Turkey Creek Regional Sewer District Raw Water Supply Well

ADDENDUM 2

October 20, 2026

W-0.2

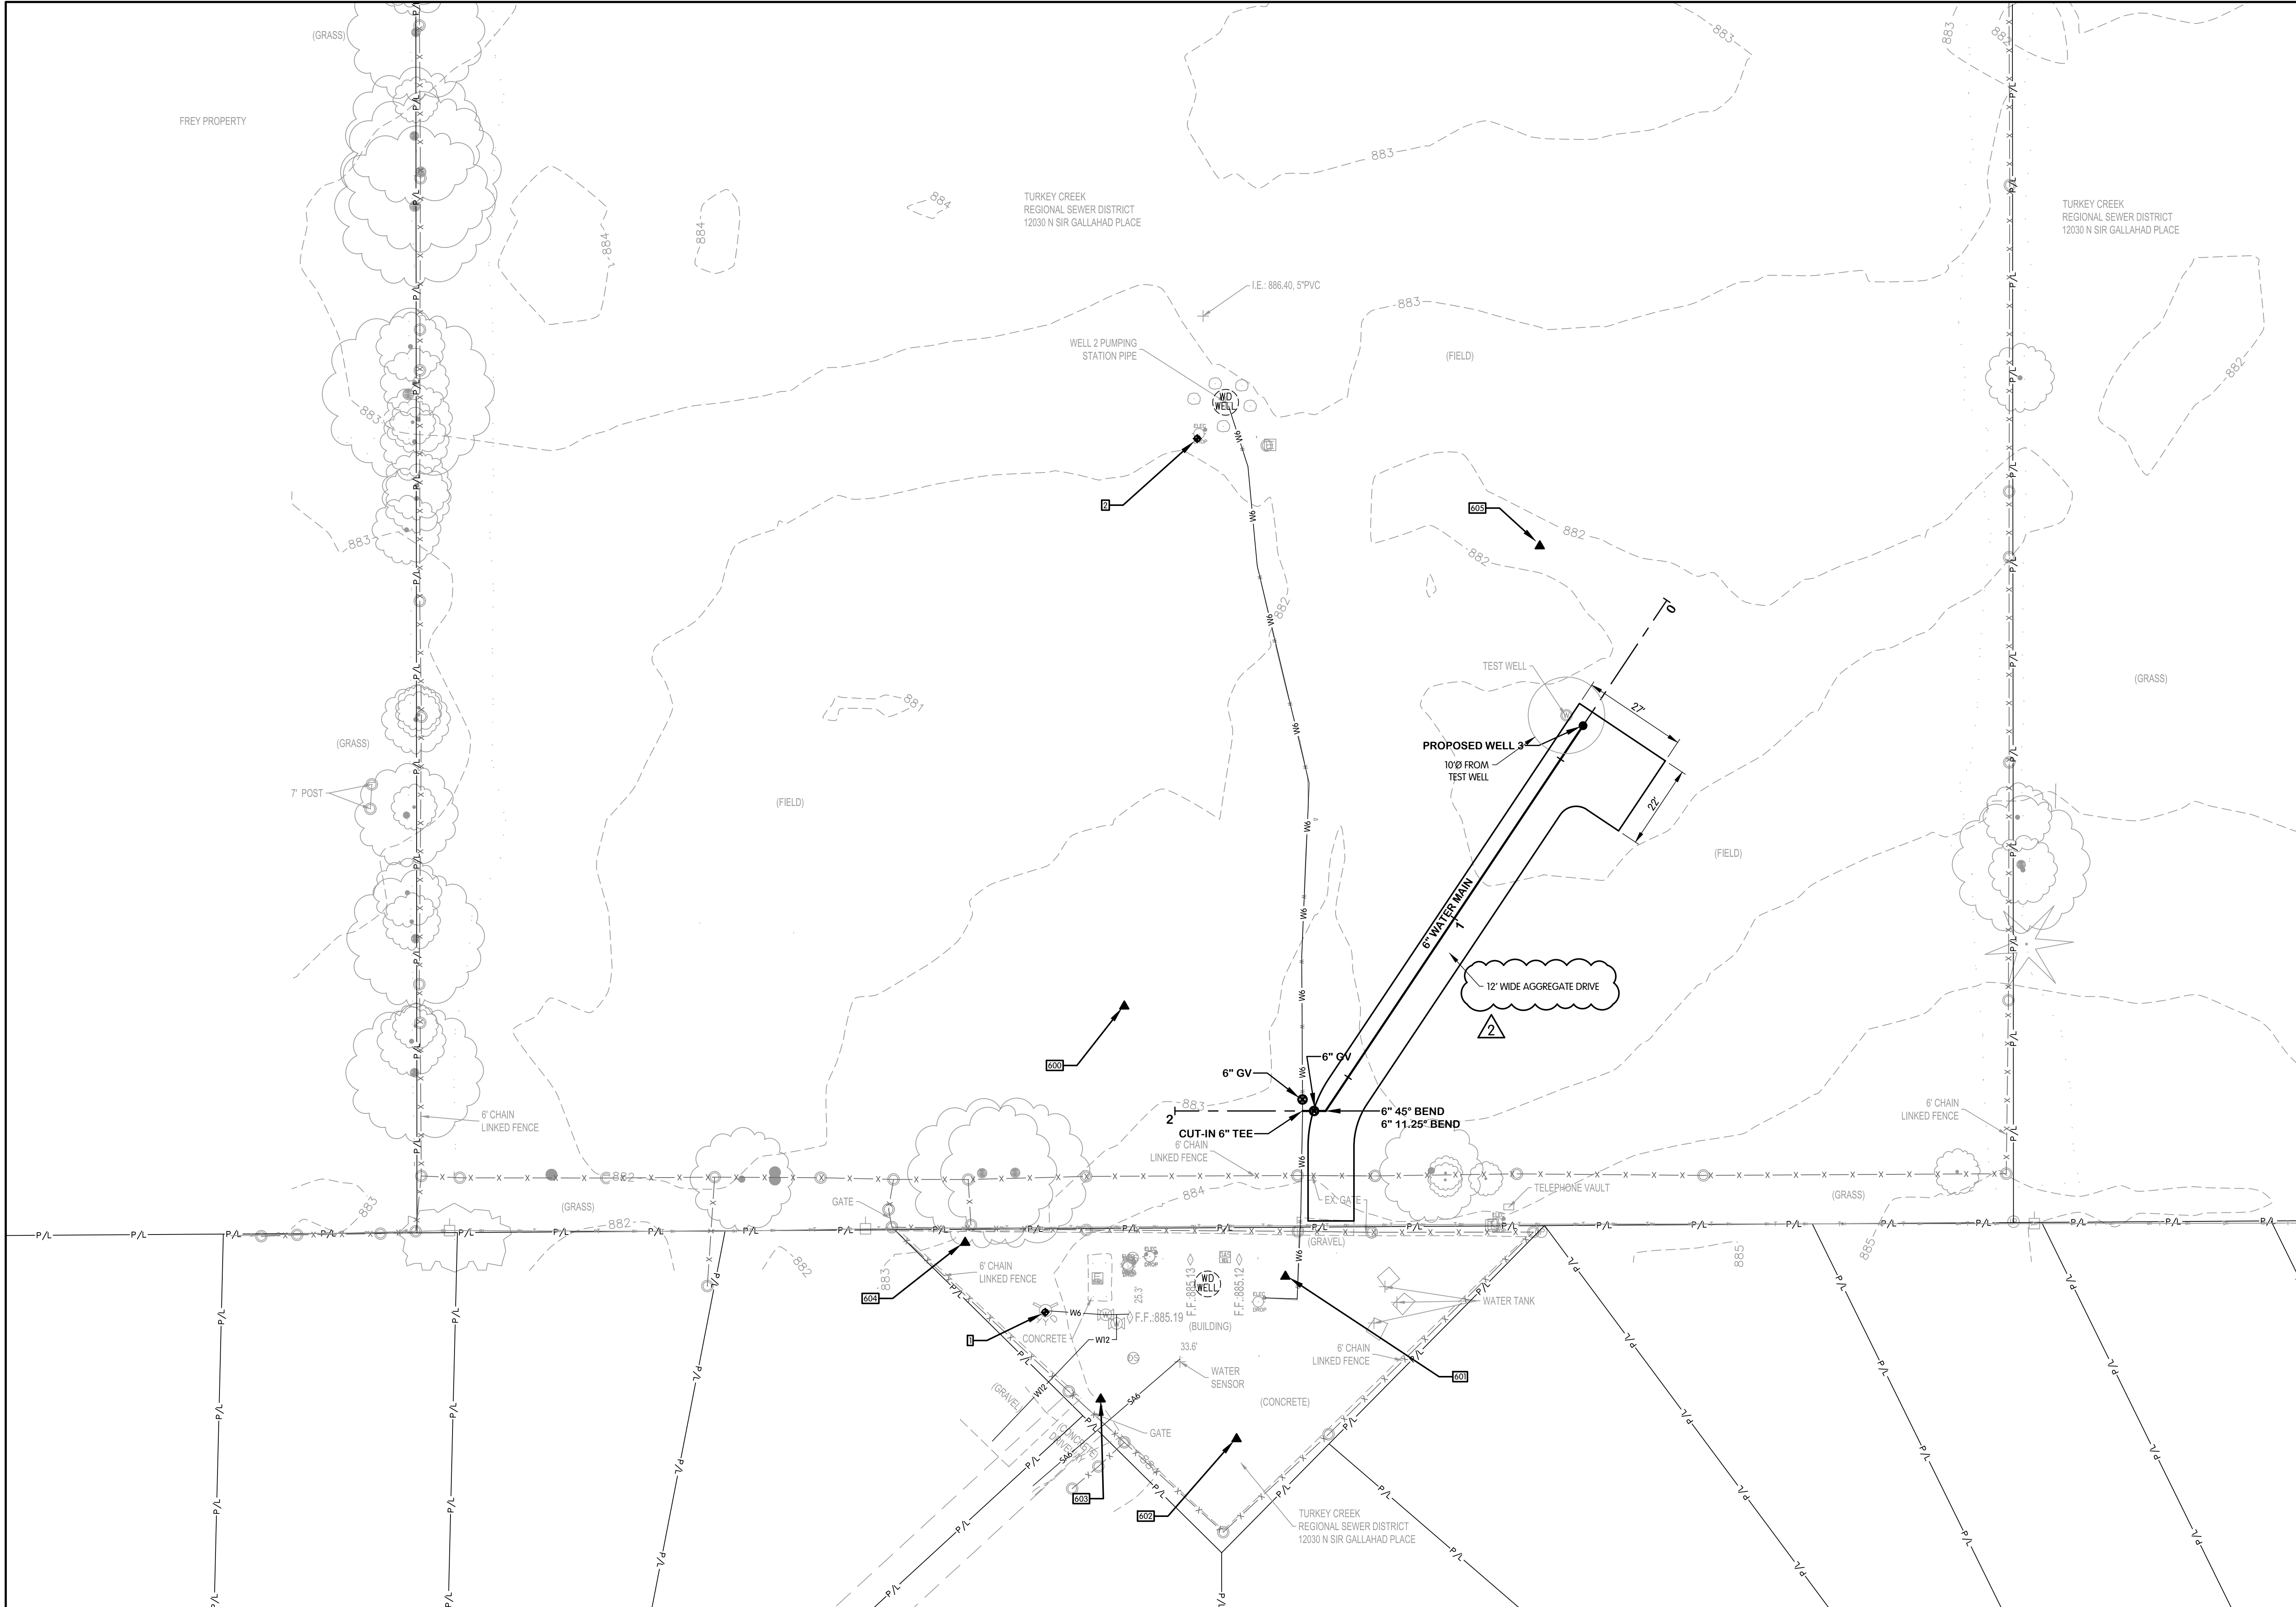
Sheets W-0.2: Delete and replace sheet, add aggregate drive detail.

SHEET NO.
W-1.1
5 OF 10

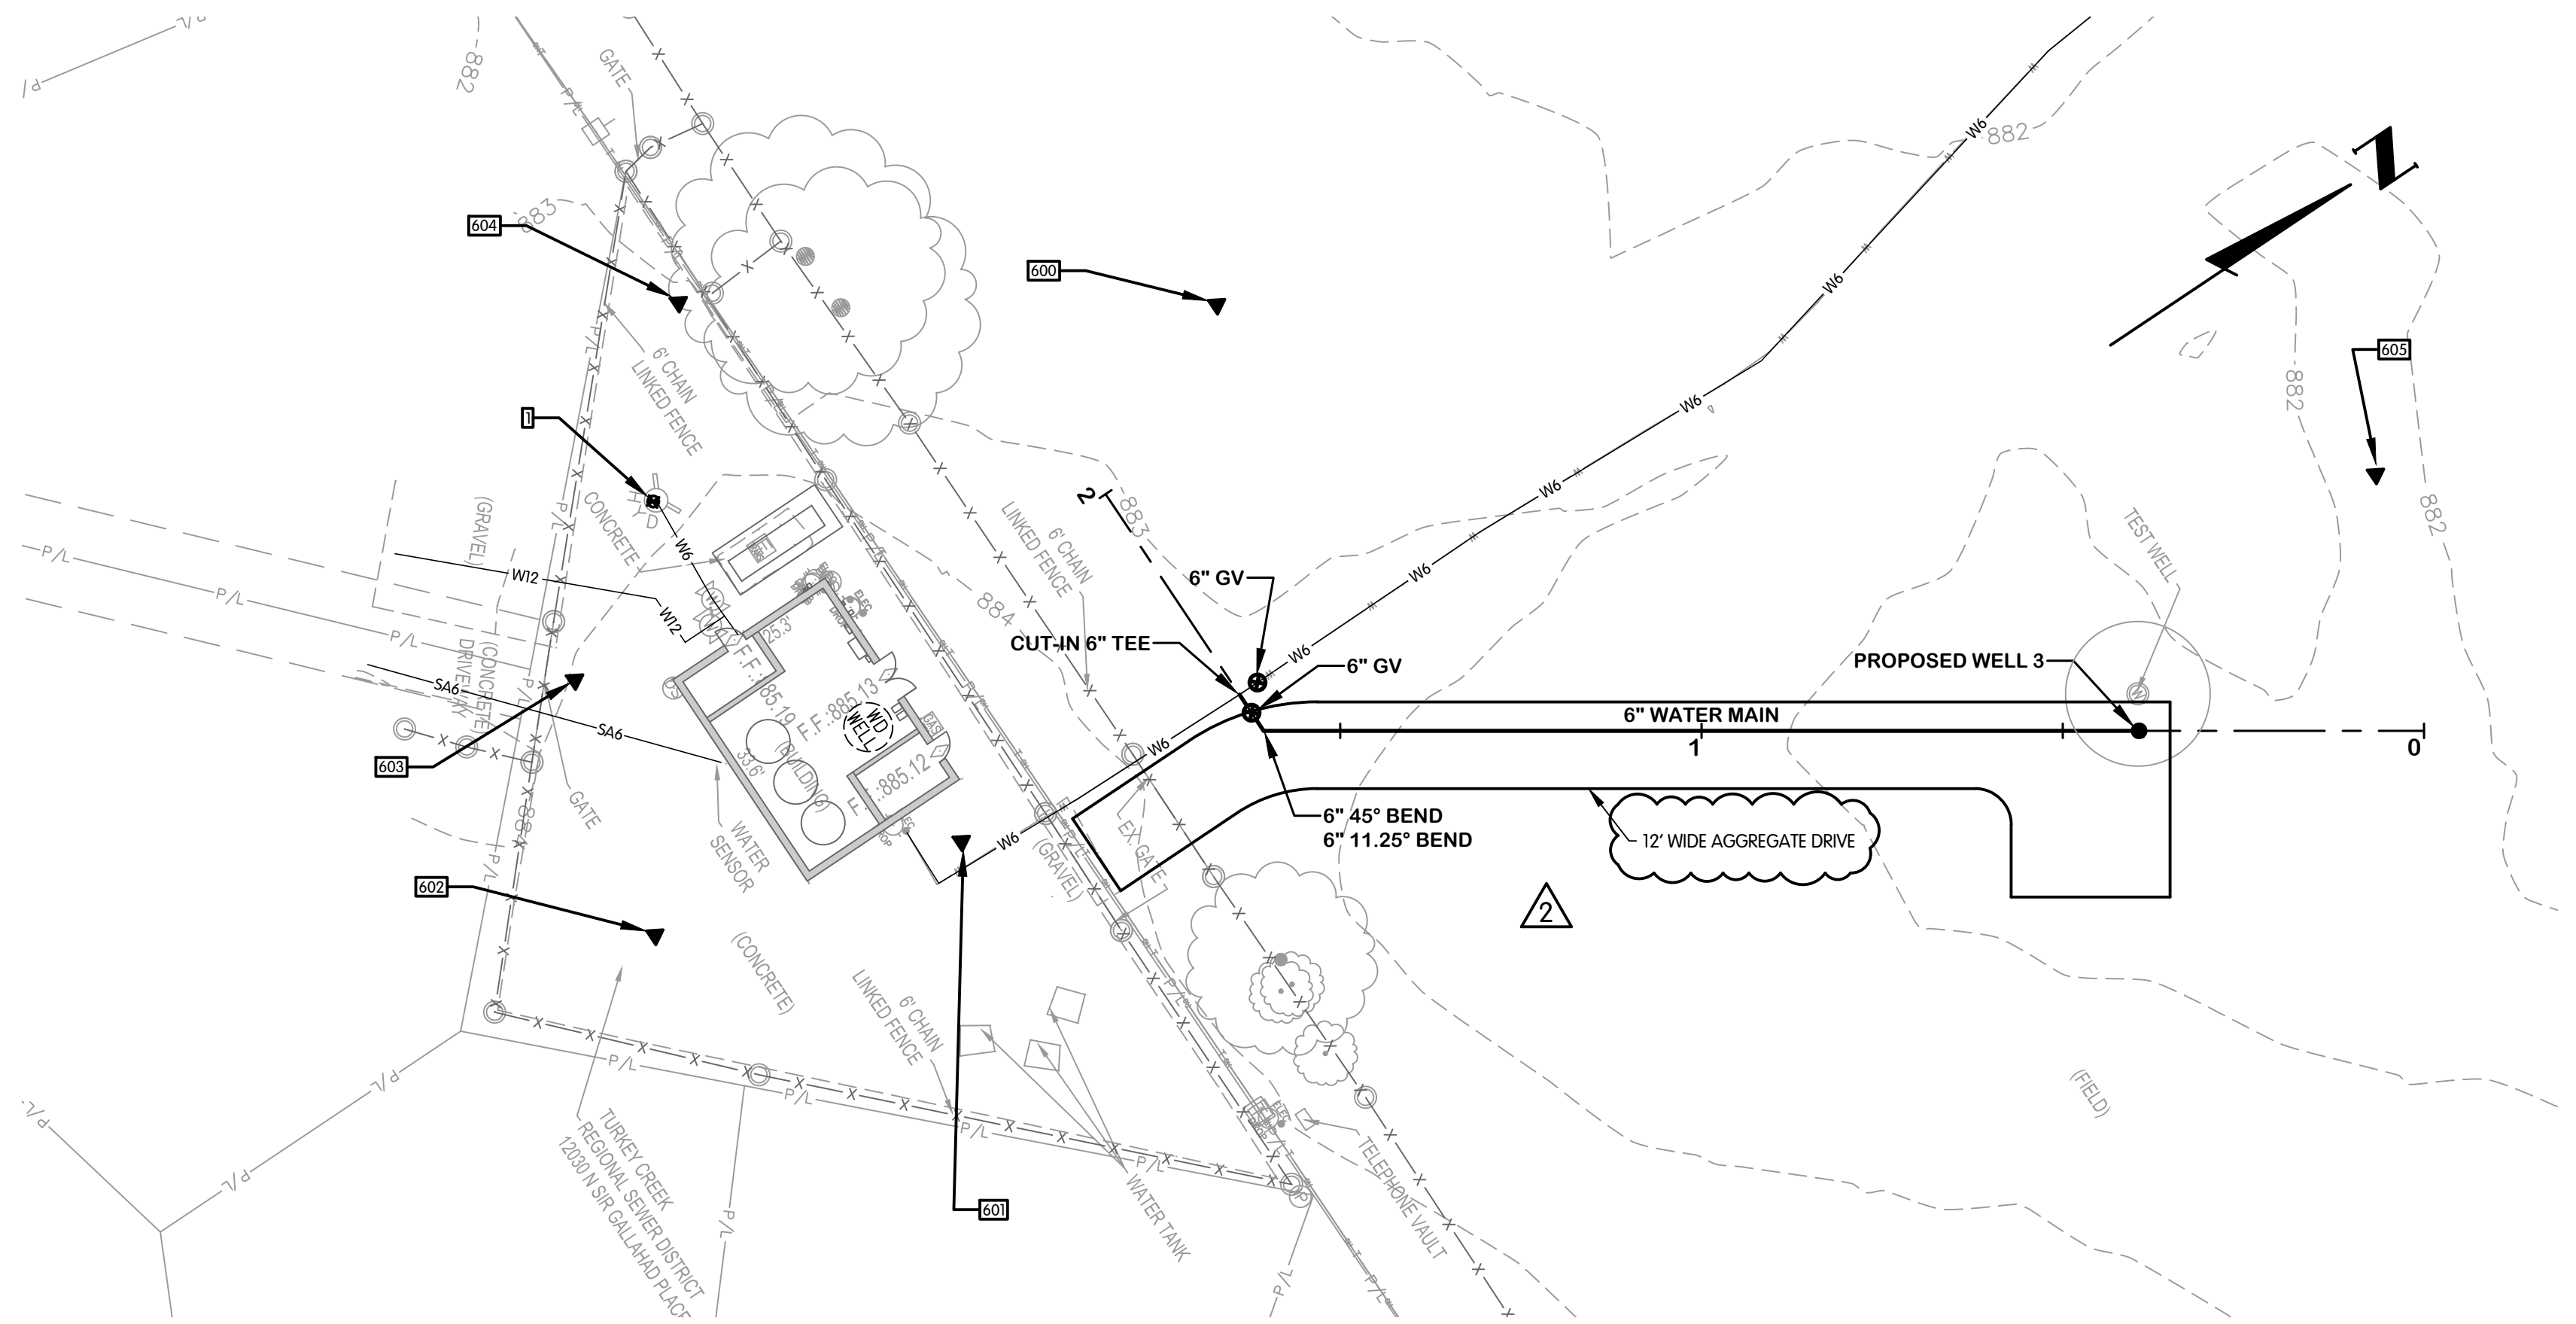
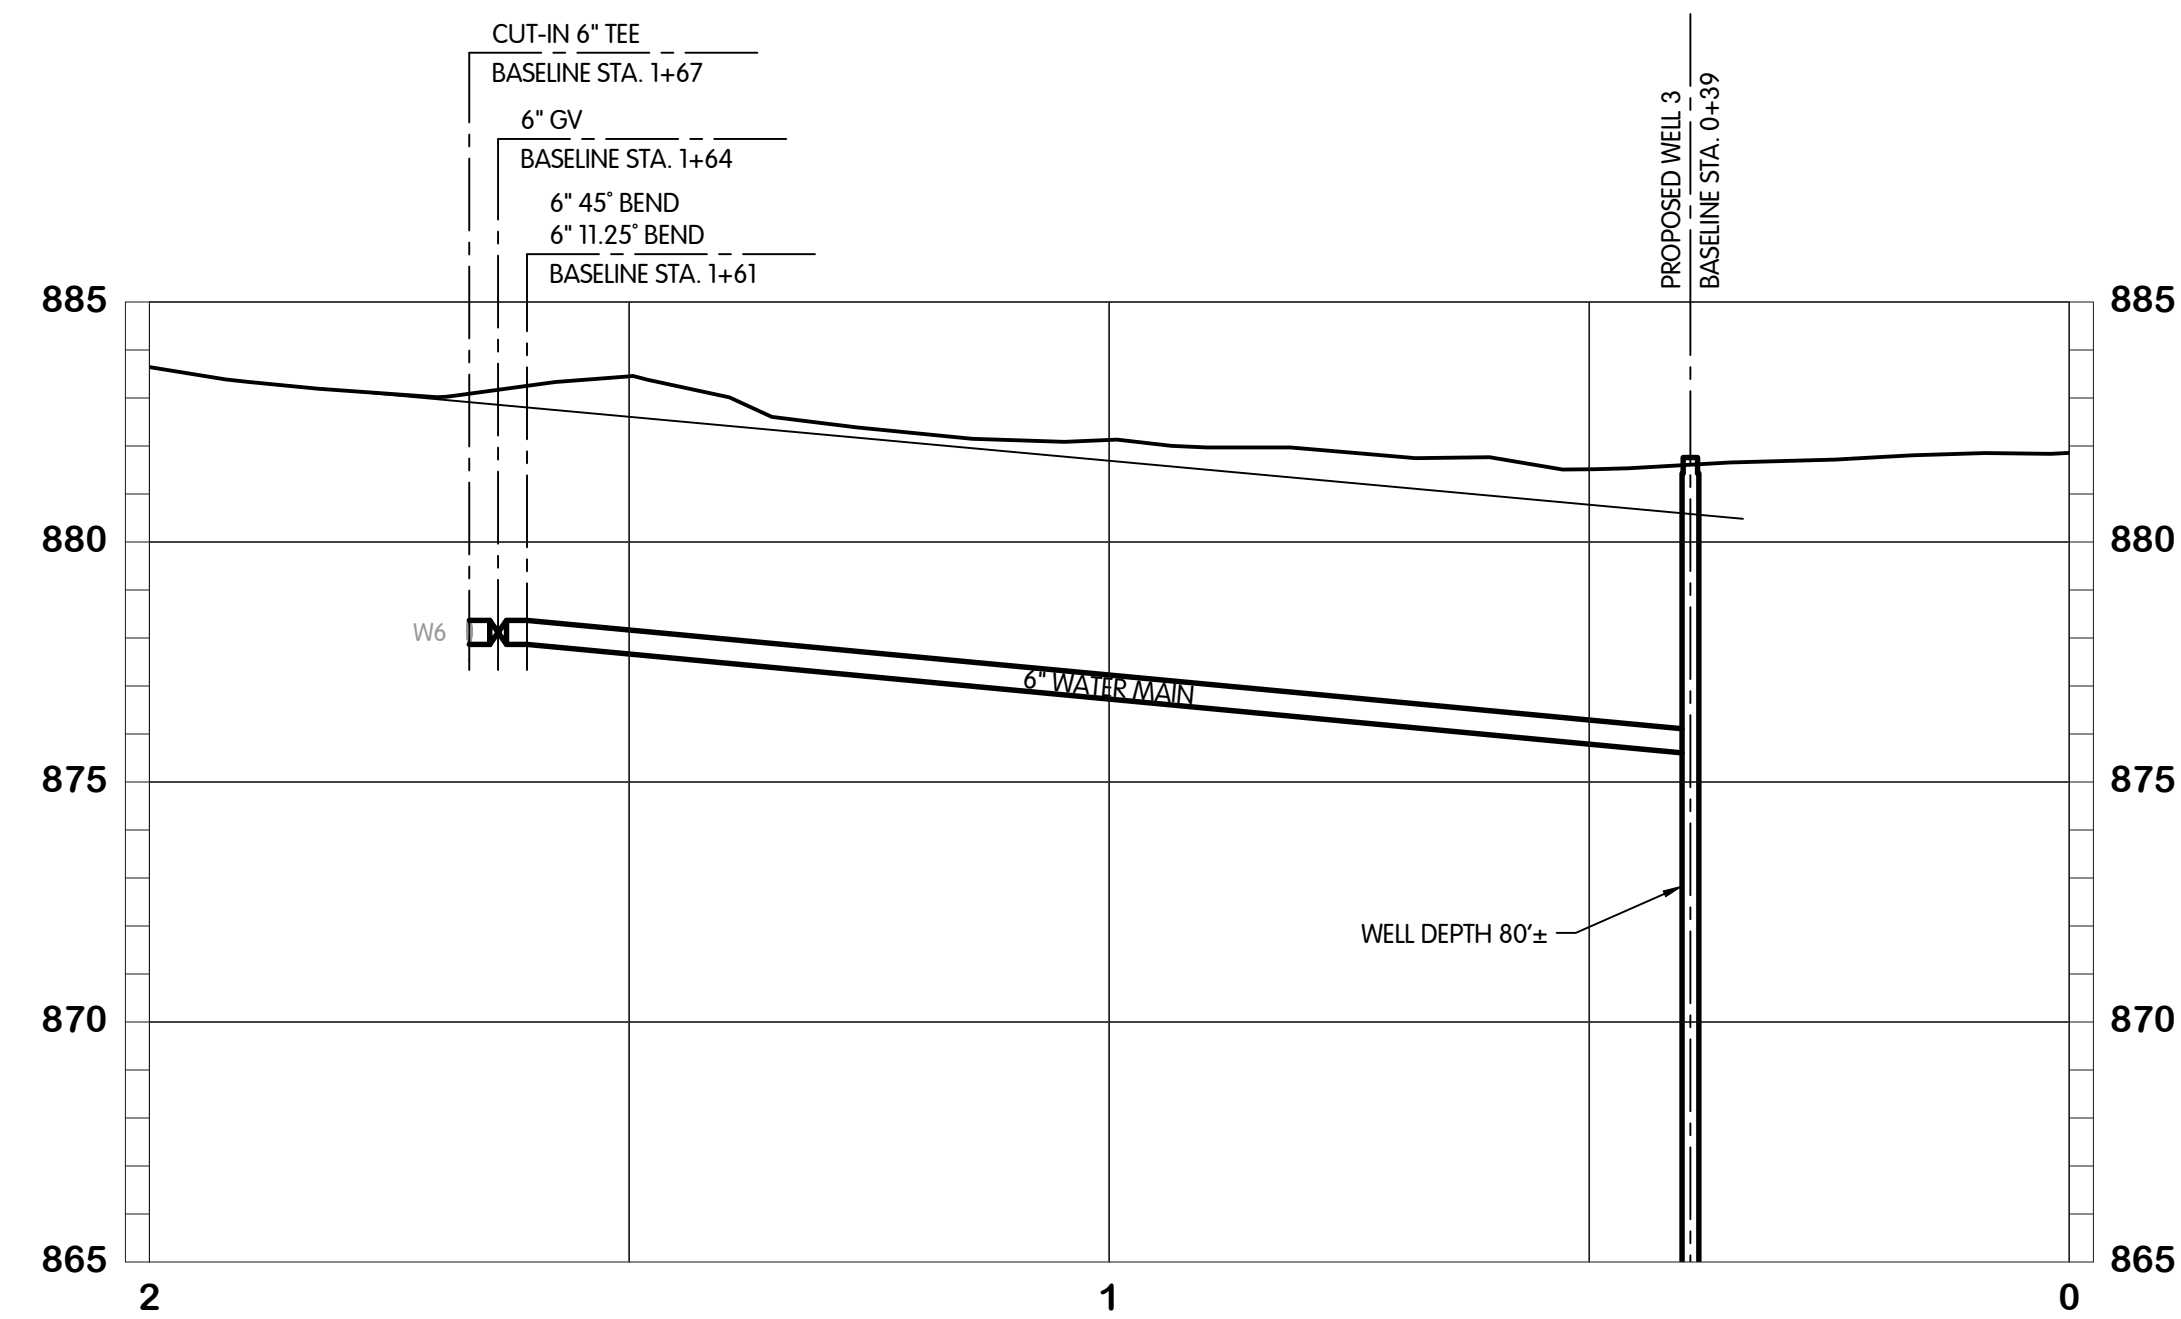
Sheets W-1.1: Delete and replace sheet, add aggregate drive to site plan.
